Airworthiness Directive Schedule

Airbus Helicopters AS 355 Series

23 July 2026

Figure: Airbus Helicopters recommended CG position of forward two-place seat.

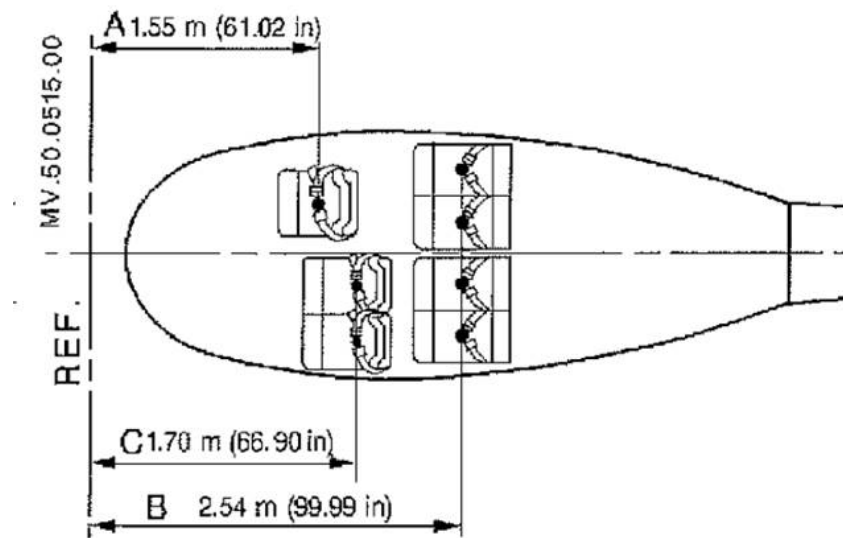
Annotate the CAA2173 to include the value of the longitudinal moment arm of the forward two-place seat used.
